SITE PLAN REVIEW AND APPEARANCE BOARD STAFF REPORT

Fifth Avenue Townhomes

Meeting	File No.	Application Type
October 23, 2024	2024-056-SPR-LV2	Level 2 Site Plan with
Property Owner		Authorized Agent
Fifth Avenue Delray, LLC		Thomas F. Carney, Jr. of Carney Stanton P.L.

Consideration of a Level 2 Site Plan to construct a five-unit townhouse development with detached garages, Architectural Elevations, and Landscape Plan with a landscape waiver and an internal adjustment to the side interior setbacks for swimming pools.

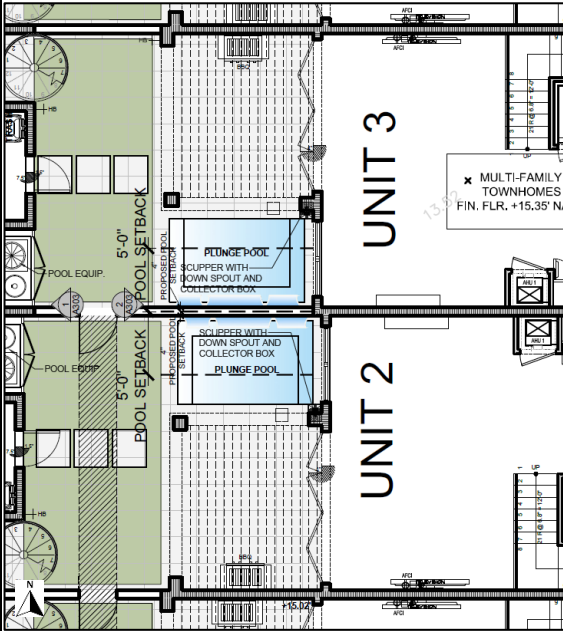
The proposed site plan generally meets all applicable requirements of the LDR aside from the identified waiver and internal adjustment. The site is configured in a manner that orients the buildings towards SE 5th Avenue with stoop frontages, and vehicular access from the rear alley. Furthermore, parking is located to the rear of the site, which helps alleviate the negative visual impact that results from an abundance of off-street parking placed between the buildings and public realm. The site configuration proposes a well-landscaped streetscape along the Primary Street, SE 5th Avenue, that leads to the unit's stoops.

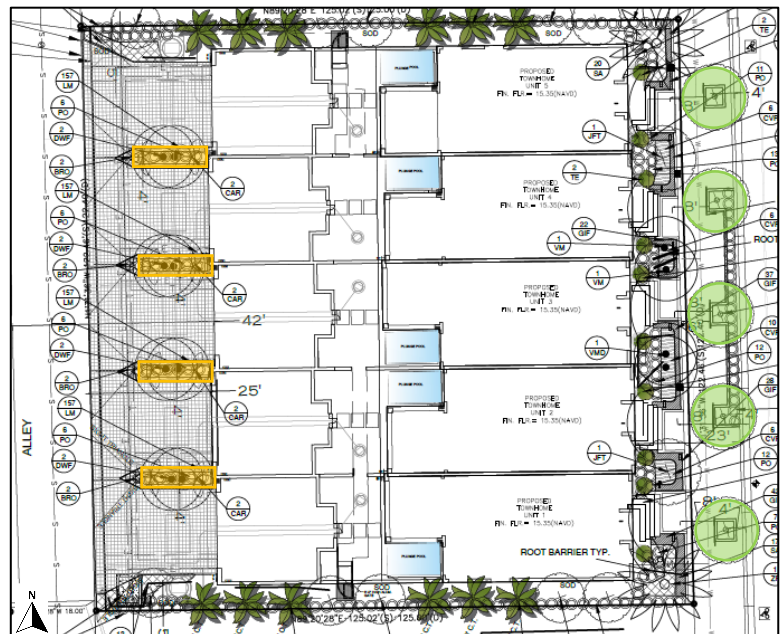
Each of the five proposed townhomes includes a swimming pool amenity between the unit and the detached garage. **LDR Section 4.6.15(G)(3)** requires a minimum five-foot side interior setback for swimming pools in townhouse developments. While the swimming pools for unit 1 and unit 5 comply with the minimum required side interior setbacks, the swimming pools for unit 2, unit 3, and unit 4 encroach into the side interior setbacks. The applicant is requesting an Internal Adjustment to allow a reduced side interior swimming pool setback of four inches in lieu of the required five feet for the swimming pools on unit 2, unit 3, and unit 4 (pictured at left).

Generally, the intent of the five-foot interior pool setback is based on safety precautions to ensure there is a clear and accessible means of ingress/egress from the pool area on all sides in the event an emergency were to occur. The swimming pools on unit 2, unit 3, and unit 4 have over five feet of clearance on two of the four sides. The applicant asserts that the narrow lot dimensions greatly constrain the feasible locations for the swimming pools. As currently configured, if

the swimming pools were shifted more central to the lots to meet the minimum interior side setbacks, they would obstruct the pathway leading to the detached garages.

The Board should determine whether allowing a four-inch side interior setback for the swimming pools on unit 2, unit 3, and unit 4 would contribute to the overall quality and functionality of the proposed development.
